CARVER CORPORATION APPLICATION BULLETIN

Application Bulletin # TX-11A-2

Model: TX-11A

REASON: This modification will provide the correct de-emphasis for the new NSRC AM format. This change was incorporated in the TX-11B.

CNR-642B FM NR/AM Accessory P.C. Board

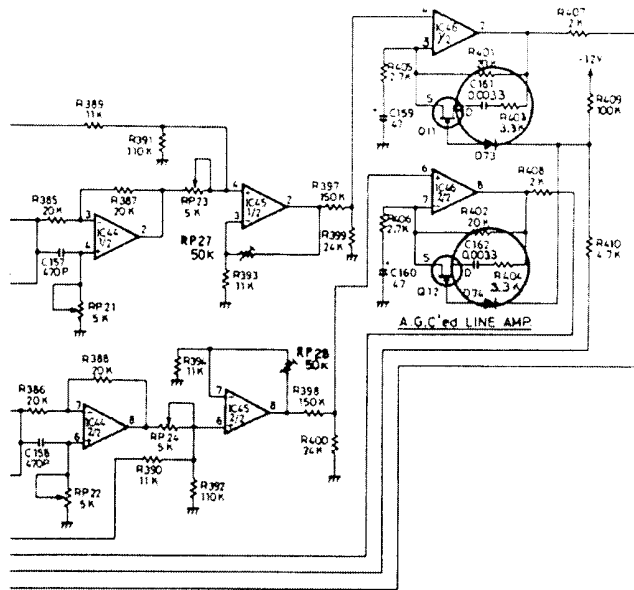
On the FM NR/AM Accessory PCB (CNR-642B), replace R403 and R404 with 3.3kΩ 1.4W resistors, and replace C161 and C162 with .0033μF capacitors, as indicated below.

Qty 2 4.7kΩ 1/4W resistor (R403,R404)
KA25ST472J
Qty 2 .0068μF mylar capacitor (C161,C162)
MY-50VU682J

Qty 2 3.3kΩ 1/4W resistor (R403,R404)
251-00082-00
Qty 2 .0033μF mylar capacitor (C161,C162)
204-00009-00
